KEYSTONE XL PIPELINE PROJECT PHASE II PIPELINE ROUTE VARIATION FORM

d) Has all the evaluation criteria be	een examined/provided for this specific discipline	Yes		No	
If no, please explain why:					
9 Originator: Doug F	Reichley		10 Received by		
Date: 7/6/	2010		Date		10
11			12	Fax to: ?	
	er: 0172-SD-P2-591.0-592.9-S		Filed by	:	
			Date	:	
			Date	Fax to: ?

KEYSTONE XL PIPELINE PROJECT PHASE - STEELE CITY SEGMENT ROUTE VARIATION AUTHORIZATION FORM							
Date:	7/6/2		Tracking N			-P2-591.0-592.9-	<u>s</u>
Description:	Reroute at MP 591 to avoid a landowner with the opposition revert back to June 16, 2008	n group and	Originate	MP: ed By:	591.0	to 592.9 Doug Reichley	
	possible to shorten the route.		Variation F	orm Attached:	Yes	X No	
Universal Fi	eld - Land	Doug Reichley	Variation:	Approved	X	Rejected	
Comments:			Doug Reich	nley	Date:	7/6/2010	
			If Rejected Why?				
State PM - C	Construction / Eng.	David Guien	Variation:	Approved	Х	Rejected	
Comments:			David Guie	n	Date:	9/18/2010	
			If Rejected Why?				
Trow - Envir	ronmental	Jonathan Minton	Variation:	Approved	Х	Rejected	
Comments:	Need to complete Bio and Cu	Itural Survey.	Jonathan N	linton	Date:	7/8/2010	
			If Reject

0172-SD-P2-591.0-592.9-S

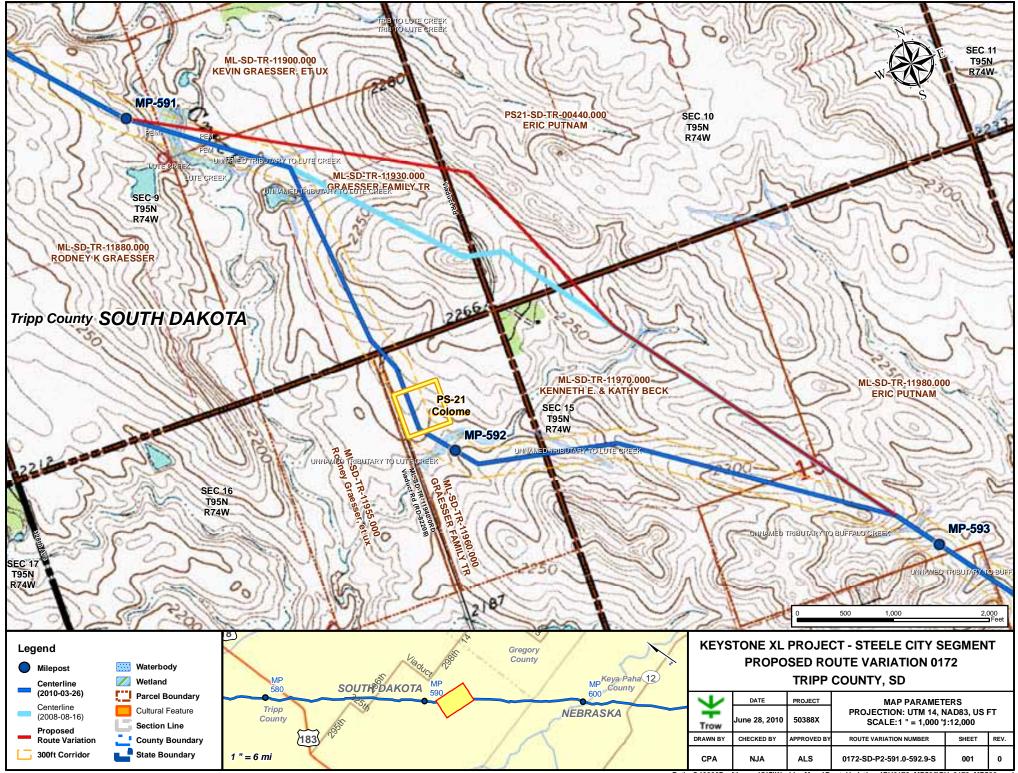
STONE PHASE IV, US PIPELINE F ROUTE VARIATION FORM			
ARIATION TYPE:	Refinement:		Reroute:	<u> </u>	
Cente	rline: X	Valve Site:		Pump S	Station:
OCATION:	Sketch:	Attached	Dictures	See attached.	
State: SD Township: 95N	County: Range:	Tripp 74W	Quad Map: Aerial Map	N/A See attached map sheet	
Section: 9, 10, 15		Centerline: 3/26/2010	MP:		to 592.90
EASON FOR ROUTE VARIA			44000 141 05		
		o Graesser Family TR (ML-SD-TR- I to shorten the centerline and reloc

• •	06/16/2008 CL) for a portion of the 0 (the primary reason for the original		djusted to avoid a terrai	in feature located at
DETAIL ROUTE VARIATION (•	· ·			
rosses Viaduct Road ~2,050 f	t north of its current cro	nd deviates slightly (~7°) towards the ssing location. The proposed rerour long its path, it makes a slight devi-	te then turns to	owards the south and co	ontinues for 5,740 ft to

•		e relocated from the current location			
lownstream since the current la	andowner (Graesser Fa	mily TR) is with an opposition grou	p. This report	does not cover the PS	S-21 relocation.
		1			
	· · · · · · · · · · · · · · · · · · ·	I impacts which may affect cost; cr			inge in each due te
	t shorter than the origin	al route. The number of horizontal f			ings in cost due to
The proposed reroute is ~667 f	t shorter than the origin	al route. The number of horizontal f			ings in cost due to
The proposed reroute is ~667 f	t shorter than the origin	al route. The number of horizontal f			ings in cost due to
The proposed reroute is ~667 f	t shorter than the origin	al route. The number of horizontal f			ings in cost due to
The proposed reroute is ~667 f hese fittings and the additional	t shorter than the origin welds are not estimate	al route. The number of horizontal f d at this stage.	ittings decreas	ses by 4, though the sav

d) Was realignment proposed to s	atisfy agency request?	Yes		No	Х
	· · · ·				
-If yes, name of	of agency(s):				
e) Environmental features:					
Added (+	·): Adds three stream crossings	Subtracted (-)	Removes 5 stre	ams and 1 pond	
	, , , , , , , , , , , , , , , , , , ,	()			
Wetland II	D # for newly impacted wetlands:
